PILATUS AIRCRAFT LTD. STANS, SWITZERLAND

**SERVICE BULLETIN**

PC-9

# AIRCRAFT STRUCTURE - GENERAL DO A CHECK OF THE MATERIAL SPECIFICATION USED DURING MANUFACTURE AND, IF NECESSARY, DO A CHECK FOR CRACKS OR REPLACE THE PART

Nose Rib 1 - Inspection (If Necessary) Figure 3

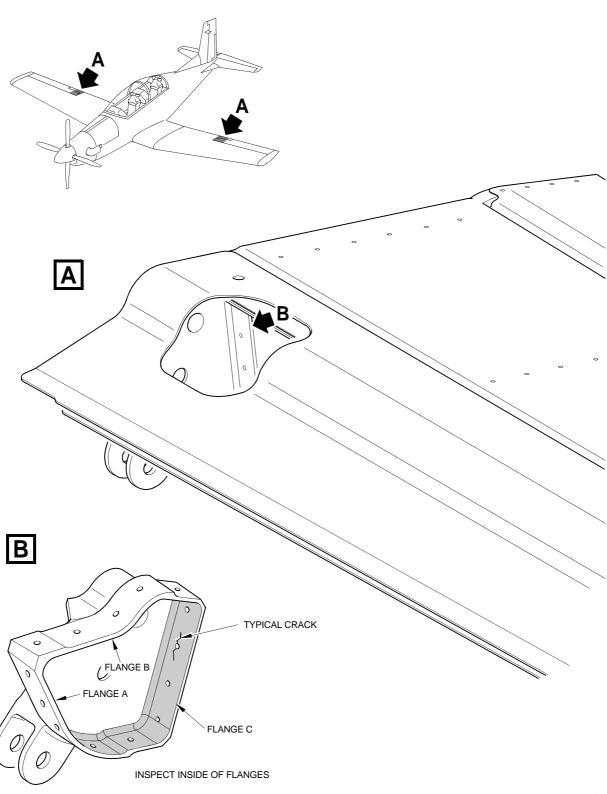
Use the absorbent paper (Material No. P02-031) made moist with the solvent 1 (Material No. P01-010) and remove the dirt and grease from the inspection areas of the left-aileron nose-rib 1 assembly (P/N 557.51.09.101).

Elevator Center-Attachment Bearing-Bracket - Inspection (If Necessary) Figure 5

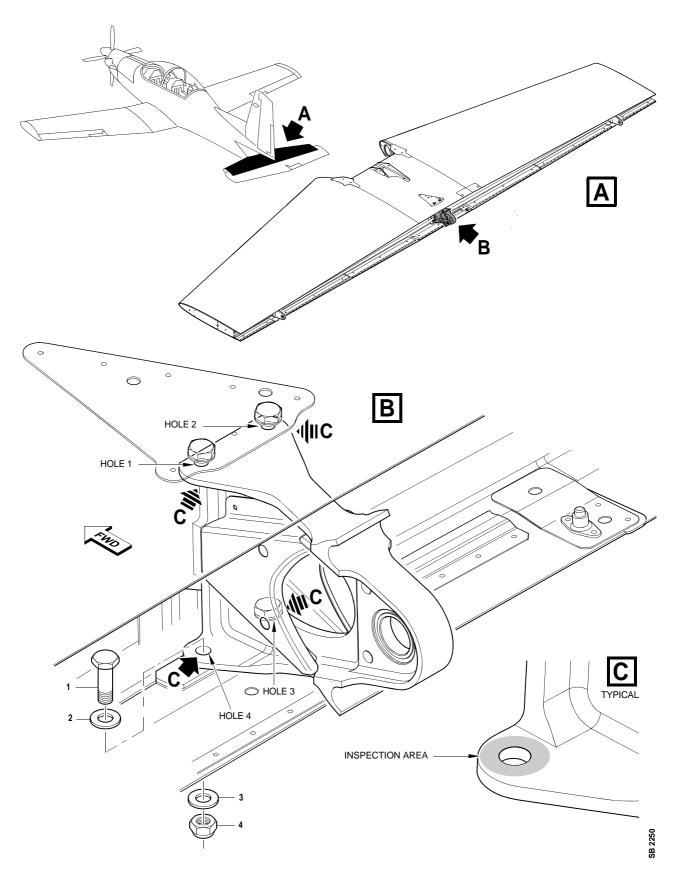
- 1 Remove the elevator assembly (Ref. 27-30-01, Page Block 401).
- From hole 4, remove the nut (4), the washer (3), the bolt (1) and the washer (2).
- Use the absorbent paper (Material No. P02-031) made moist with the solvent (Material No. P01-010) and remove the dirt and grease from the inspection areas of the elevator center-attachment bearing-bracket.

Lower Rudder Bracket - Inspection (If Necessary) Figure 7

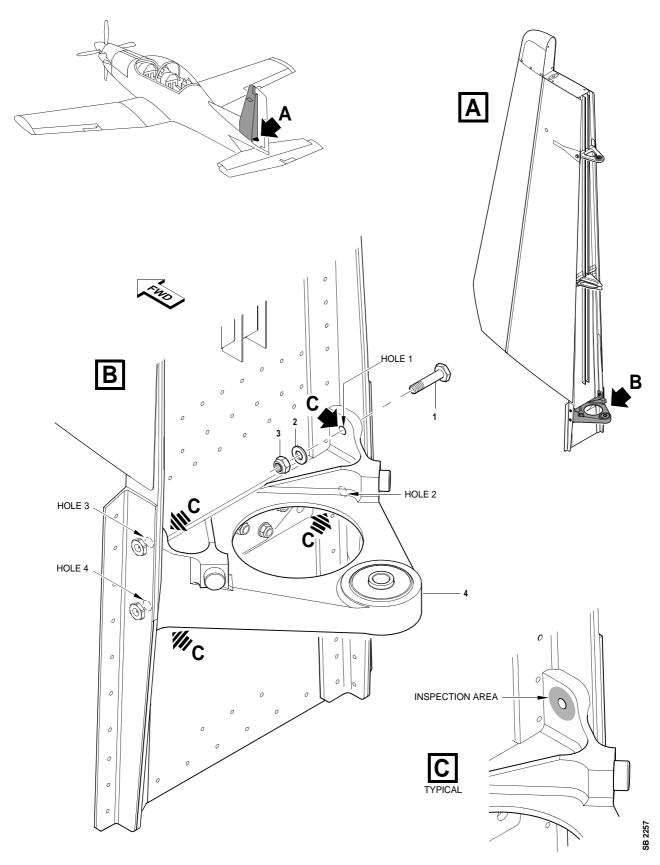
- 2 Remove the nuts (3), the washers (2) and the bolts (1) from the four attachment bolt holes of the rudder lower-hinge-bracket (4).
- Use the absorbent paper (Material No. P02-031) made moist with the solvent (Material No. P01-010) and remove the dirt and grease from the inspection areas of the rudder lower-hinge bearing-bracket.

Frame 3 Pick-Up Brackets - Inspection (If Necessary) Figure 9

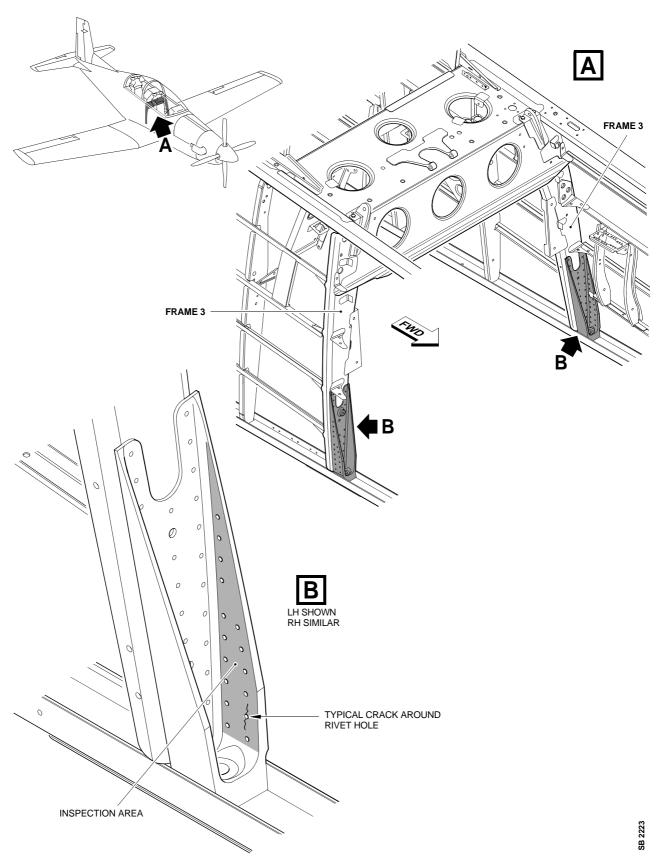
Use the absorbent paper (Material No. P02-031) made moist with the solvent (Material No. P01-010) and remove the dirt and grease from the inspection areas of the left frame 3 pick-up bracket.

Left and Right Flap Bearing Support-Bracket - Inspection (If Necessary) Figure 11

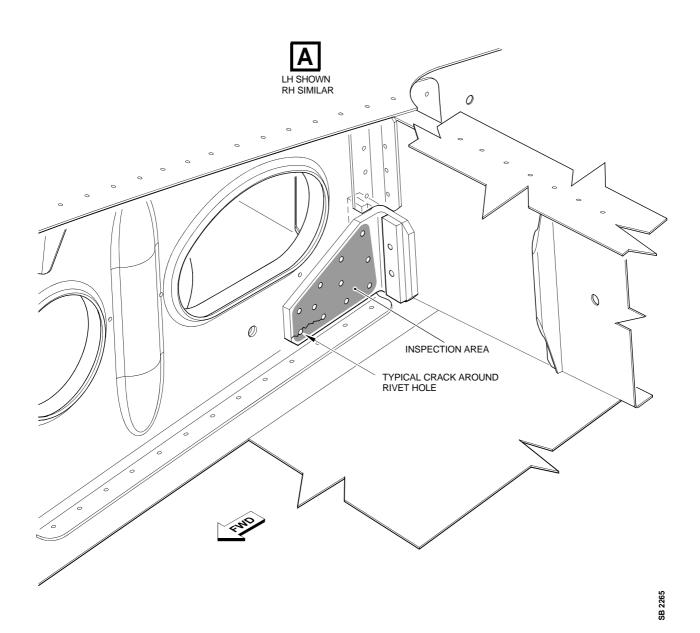
- (a) Do the conductivity test to find the material of the left flap bearing support-bracket (P/N 111.34.07.329) and the right flap bearing support-bracket (P/N 111.34.07.330) (Ref. Fig. 11).
  - Remove the dirt and grease from the areas (where you will do the test) with 1 the absorbent paper (Material No. P02-031) made moist with the solvent (Material No. P01-010).

Use the absorbent paper (Material No. P02-031) made moist with the solvent (Material No. P01-010) and remove the dirt and grease from the inspection areas of the left flap bearing support-bracket.

Rear Control-Column Support-Bearing Bracket - Inspection (If Necessary) Figure 13, Sheet 1 of 2

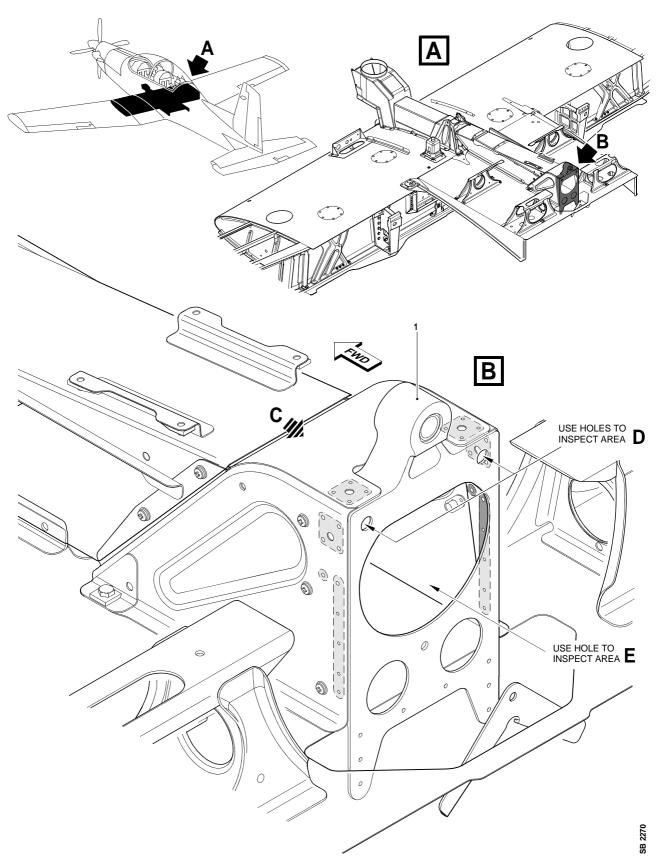
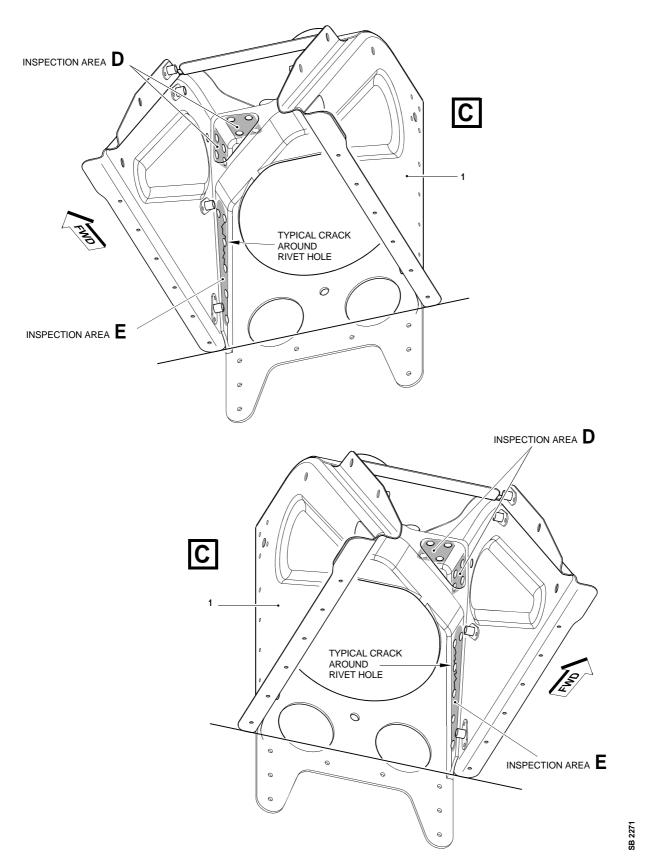
If necessary, use the absorbent paper (Material No. P02-031) made moist with the solvent (Material No. P01-010) and remove the dirt and grease from the inspection areas of the rear control-column support-bearing bracket (1).

Inspection / Replacement of the Lever on the Rear Control Column Figure 15, Sheet 1 of 2

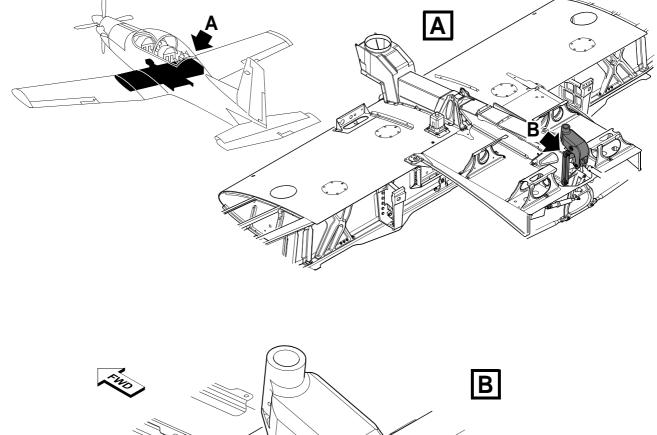
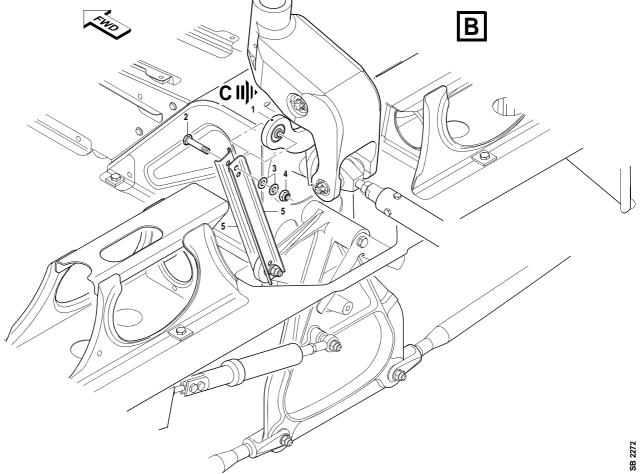
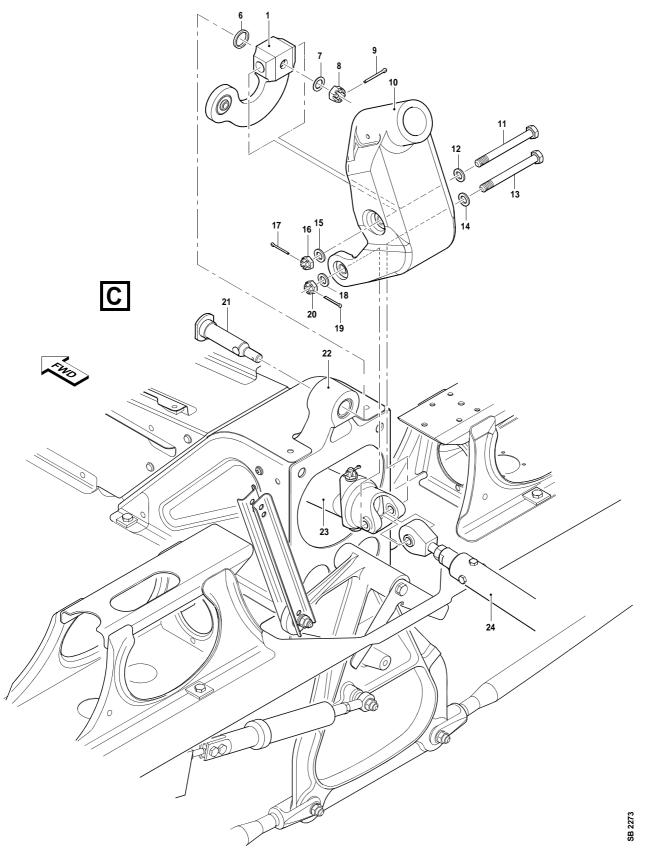
- (a) Do the conductivity test to find the material of the lever (Ref. IPC, 27-10-01) on the rear control-column.
  - <u>1</u> Remove the dirt and grease from the areas (where you will do the test) with the absorbent paper (Material No. P02-031) made moist with the solvent (Material No. P01-010).

- 8 Remove the rear control column assembly (10) from the aircraft.
- 9 Remove, and discard, the cotter pin (9).
- 10 Remove the nut (8), the washer (7), the special washer (6) and the special bolt (21) from the rear control-column support-bearing bracket (22).

- 11 Remove, and discard, the lever assembly (1) from the aircraft.
- 12 Put the new lever assembly (1) (P/N 527.30.09.223) in position in the aircraft.

Elevator Center Control-Rod - Inspection (If Necessary) Figure 16

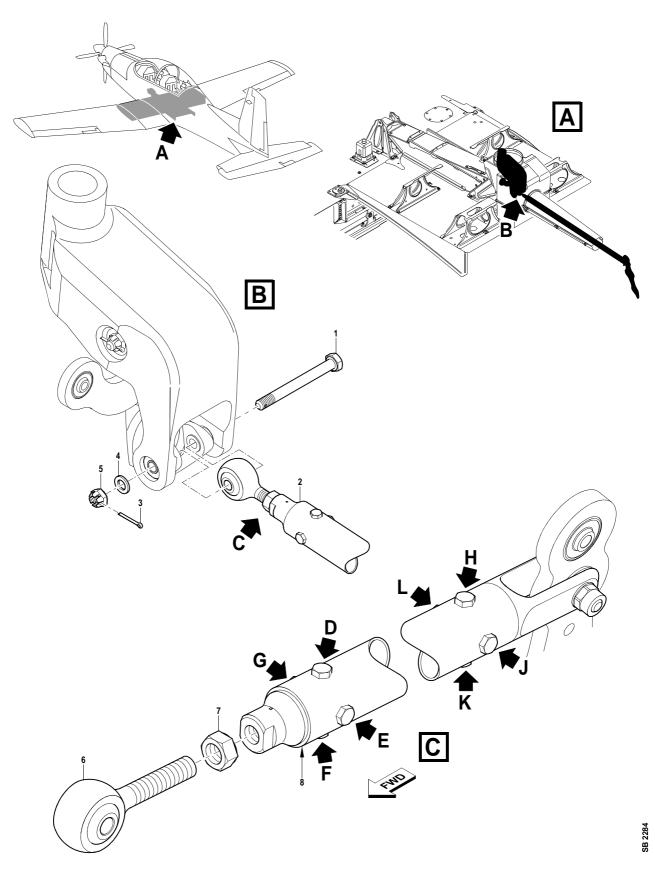
- 1 Remove, and discard, the cotter pin (3).
  - 2 Remove the nut (5), the washer (4) and the bolt (1).
  - <u>3</u> Disconnect the elevator center control-rod (2).

- <u>5</u> Loosen the lock nut (7) sufficiently to turn the end fitting (6).
  - 6 Hold the lock nut (7) and remove the end fitting (6).
- (c) Do an inspection for cracks (Ref. Fig. 16):

Elevator Rear Control-Rod - Inspection (If Necessary) Figure 18

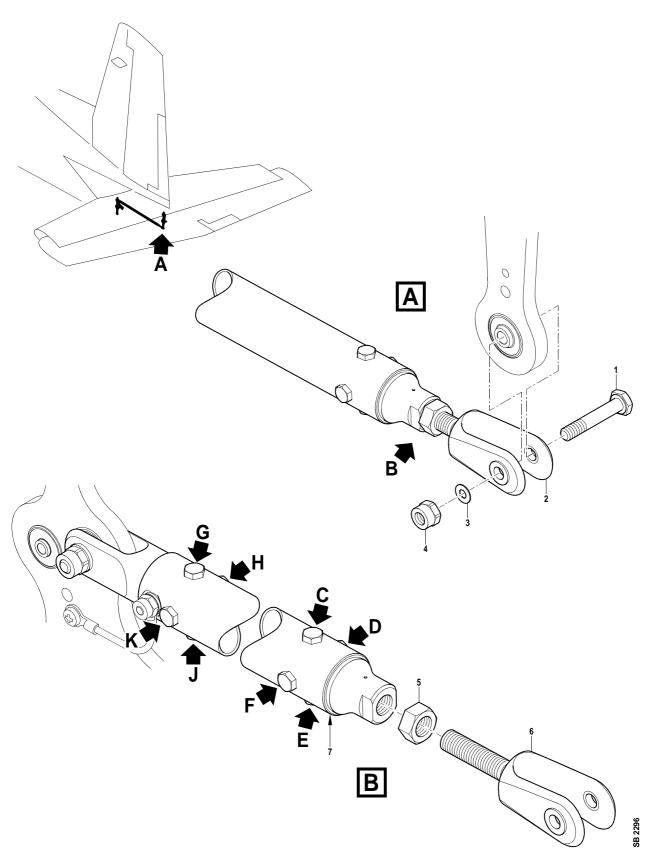
- 1 Remove the nut (4), the washer (3) and the bolt (1).
  - 2 Disconnect the elevator rear control-rod (2).
  - <u>3</u> Measure, and make a note of, the distance between:

- 5 Hold the lock nut (5) and remove the end fitting (6).
- (c) Do an inspection for cracks (Ref. Fig. 18):
  - 1 Put the boroscope into the elevator rear control-rod (2) (P/N 527.30.09.016). Do this through the hole for the end fitting (6).

Replacement of the Bearing on the Forward Control Column Figure 20

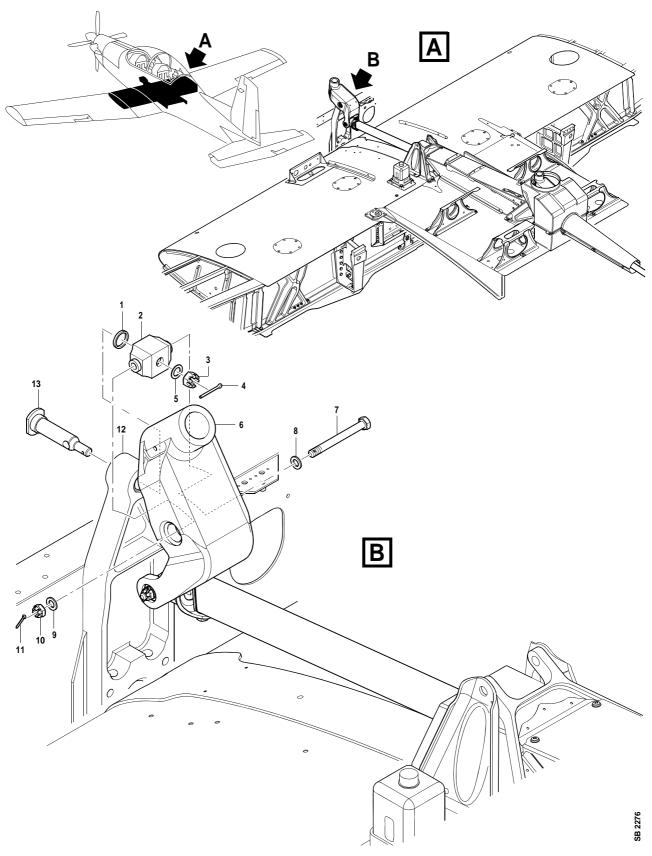
(d) Replace the bearing assembly (Ref. Fig. 20):

**NOTE:** Step 3.B.(10)(d) is only applicable to bearings made from AA2024-T351.

- 1 Remove, and discard, the cotter pin (11).
- Remove the nut (10), the washer (9), the washer (8) (if installed) and the bolt (7).
- <u>3</u> Move the control lever assembly (6) towards the rear of the aircraft to get access to the bearing assembly (2).

- 4 Remove, and discard, the cotter pin (4).
- 5 Remove the nut (3), the washer (5), the special washer (1) and the special bolt (13) from the rear control-column support bearing assembly (12).

- 6 Remove, and discard, the bearing assembly (2) from the aircraft.
- <u>7</u> Put the new bearing assembly (2) (P/N 527.30.09.221) in position in the aircraft.

Inspection and, if necessary, Replacement of the Shackles on the Elevator Control Cable Figure 21

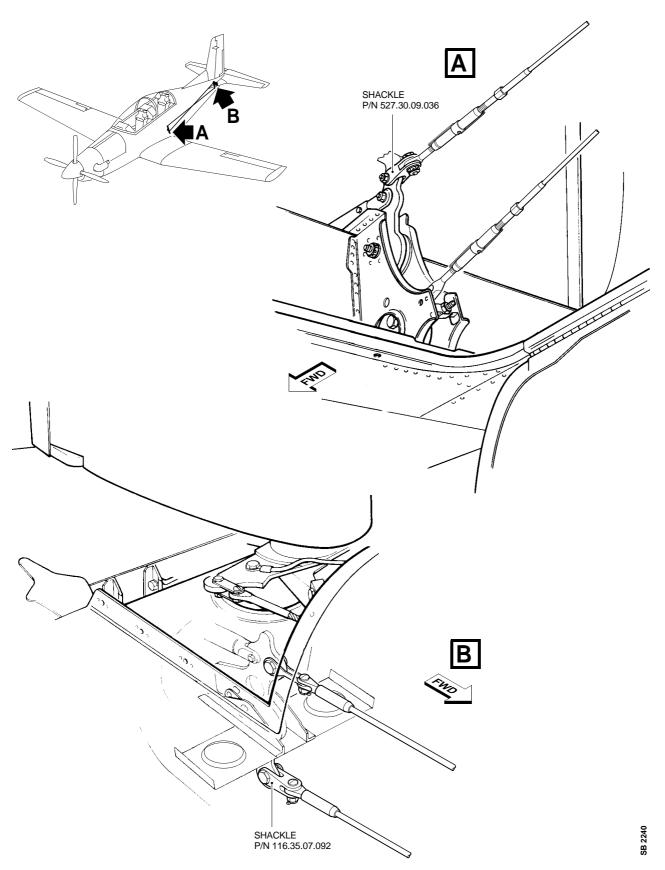
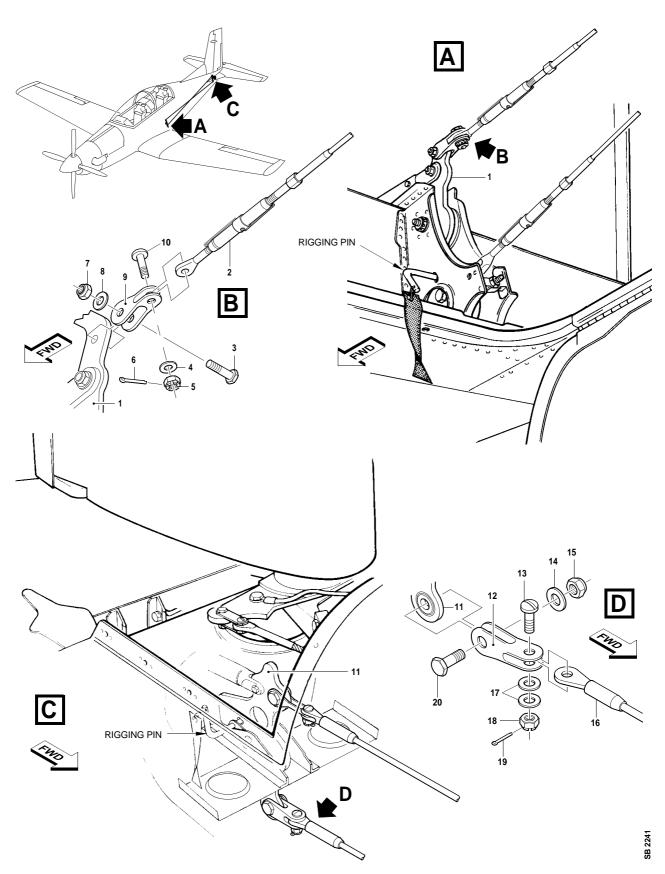
- (a) Do the conductivity test to find the material of the shackles, P/N 527.30.09.036 and P/N 116.35.07.092 (Ref. IPC, 27-30-01) on the elevator control cable (P/N 527.30.09.005).
  - Get access to both attachment points of the elevator control cable (P/N 527.30.09.005) (Ref. IPC, 27-30-01) (Refer to AMM, 27-20-02 for further information).
  - Remove the dirt and grease from the areas (where you will do the test) with the absorbent paper (Material No. P02-031) made moist with the solvent (Material No. P01-010).

- 3 At the front lever, identify the control cable (2) (P/N 527.30.09.005).
- A Remove and discard the locking clips from the turnbuckles (Refer to AMM, 27-20-02 for further information).

- 5 Loosen the turnbuckles to release the tension from the control cable (2) (P/N 527.30.09.005).
- 6 Remove, and discard, the cotter pin (6), the nut (5), the washer (4) and the bolt (10) that connect the shackle (9) to the control cable (2).

- Remove the nut (7), the washer (8) and the bolt (3) that connect the shackle (9) to the lever (1).
- 8 Remove, and discard, the shackle (9) from the aircraft.

- 12 Install the bolt (3), the washer (8) and the nut (7) that connect the shackle (9) to the lever (1).
- 13 Install the bolt (10), the washer (4) and the nut (5) that connect the shackle (9) to the cable (2).
- 14 Safety the nut (5) with the new cotter pin (6) (P/N 940.17.02.340).
- 15 If the shackle (P/N 116.35.07.092) is made from AA2024-T351, continue this Service Bulletin from Step 3.B.(9)(f).
- 16 If the shackle (P/N 116.35.07.092) is made from AA2124-T851, continue this Service Bulletin from Step 3.B.(9)(f)15.
- (f) Replace the shackle (P/N 116.35.07.092) (Ref. Fig. 21 and Fig. 22):

- 1 Make sure that the elevator is in the neutral position.
- <u>2</u> Install rigging pins (P/Ns 110.85.07.050 and 513.27.72.001) at the front and rear levers (1) and (11).
- 3 At the rear lever (11), identify the control cable (16) (P/N 527.30.09.005).
- 4 Remove and discard the locking clips from the turnbuckles (Refer to AMM, 27-20-02 for further information).
- 5 Loosen the turnbuckles to release the tension from the control cable (16) (P/N 527.30.09.005).
- 6 Remove the nut (15), the washer (14) and the bolt (20) that connect the shackle (12) to the lever (11).
- <u>7</u> Remove, and discard, the cotter pin (19), the nut (18), the washers (17) and the bolt (13) that connect the shackle (12) to the control cable (16).

Aileron Outer Control-Rod - Inspection (If Necessary) Figure 23

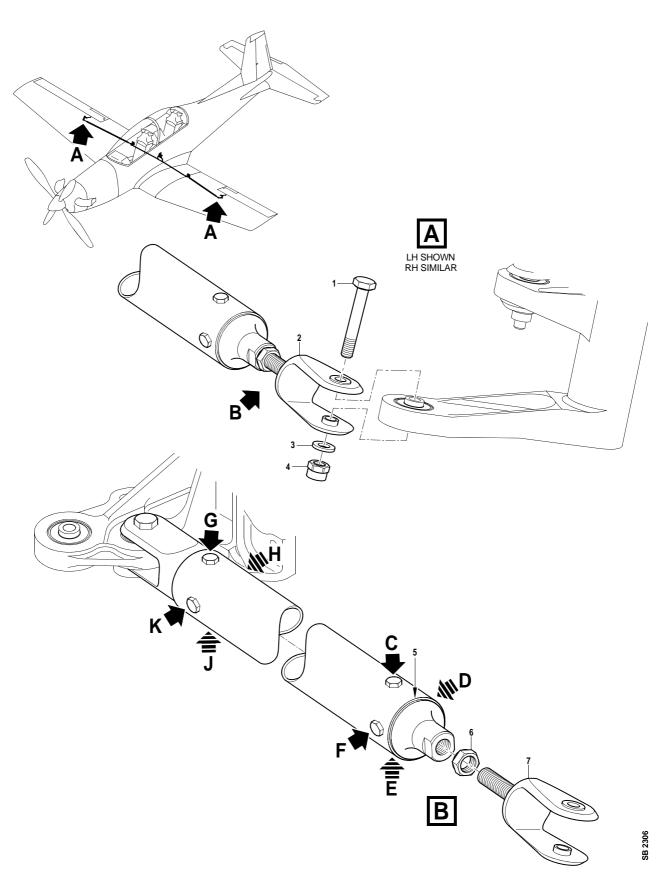
- 1 Remove the nut (4), the washer (3) and the bolt (1).
  - <u>2</u> Disconnect the aileron outer control-rod (2).
  - 3 Measure, and make a note of, the distance between:

- 5 Hold the lock nut (6) and remove the end fitting (7).
- (c) Do an inspection for cracks (Ref. Fig. 23):
  - 1 Put the boroscope into the left aileron outer control-rod (2). Do this through the hole for the end fitting (7).
